New AMP b/d+DVT2 Main Board Rework SOP

Figure 4: R3009 location on main board

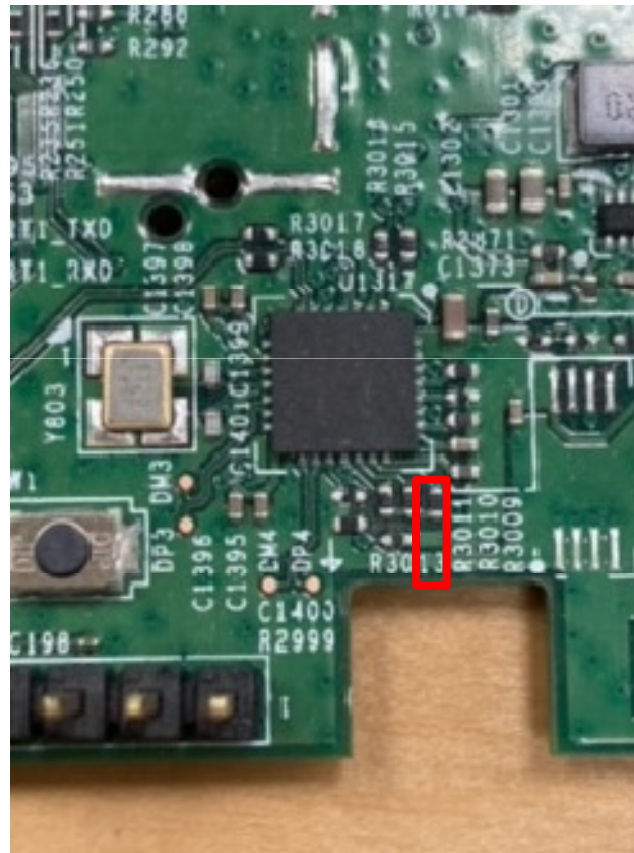
- Please remove R3009, to enable port3 of USB HUB

Figure 5: Rework guide of buffer IC

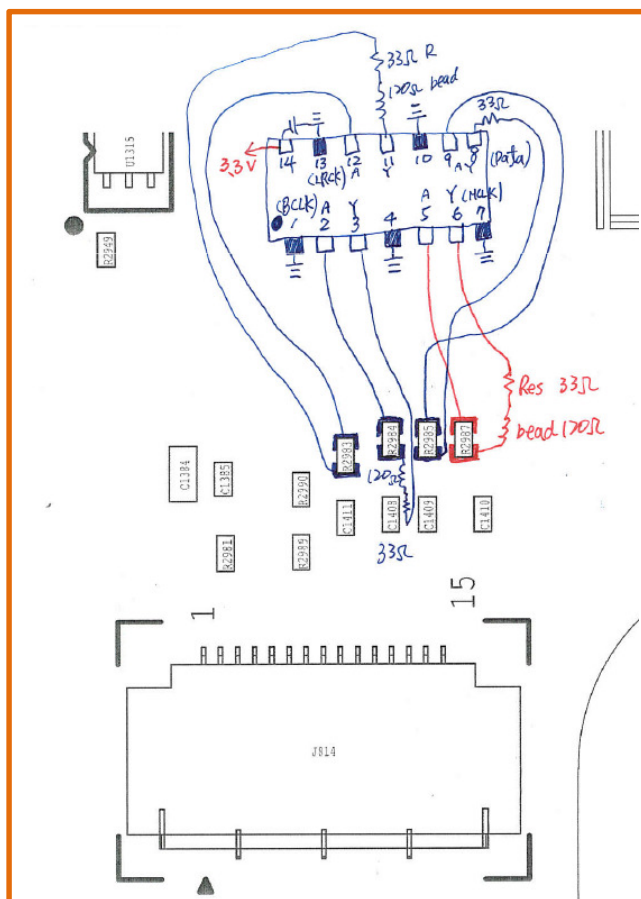
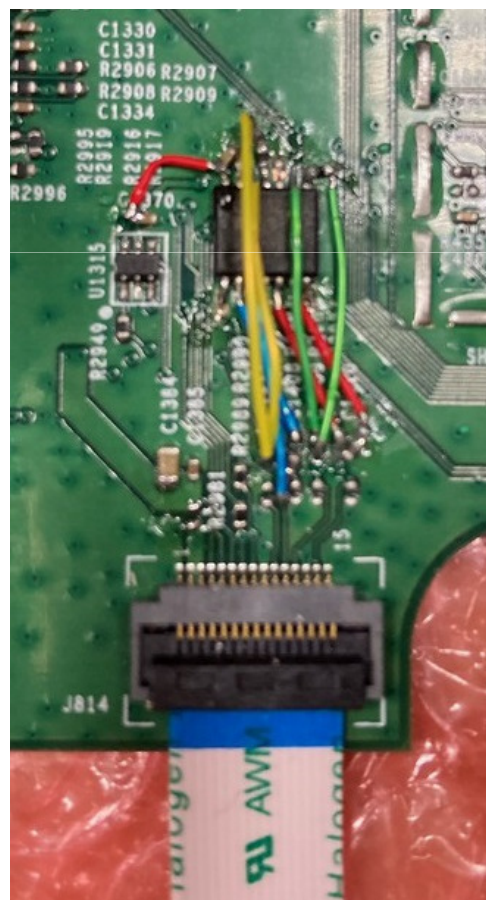
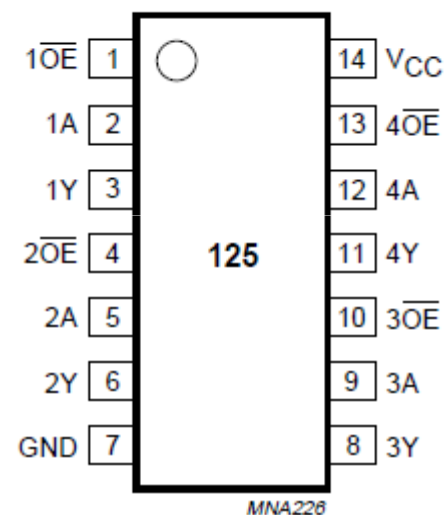
- If I2S bus has output gap issue of AMP board, PLS add a buffer IC (74LVC125APW) near J814.

Figure 8: U3_3 schematic of DVT2 LED board

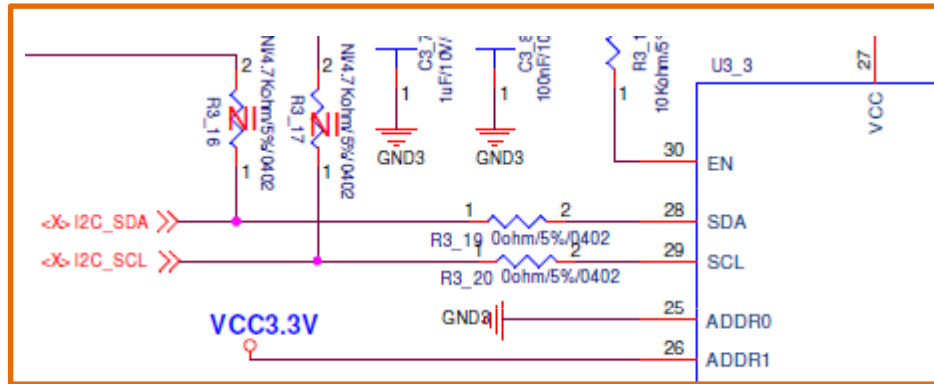
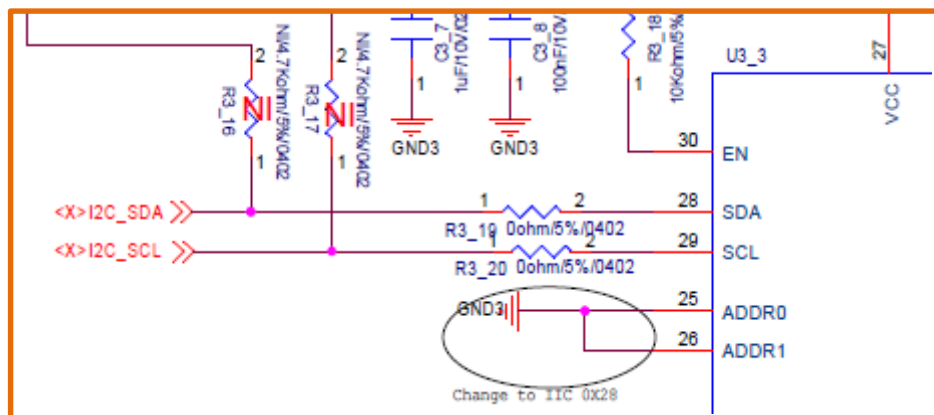
- Please cut connection between VCC3.3V and pin26 of U3_3, then short pin25 and pin26 together. To avoid I2C address conflict with AMP IC.
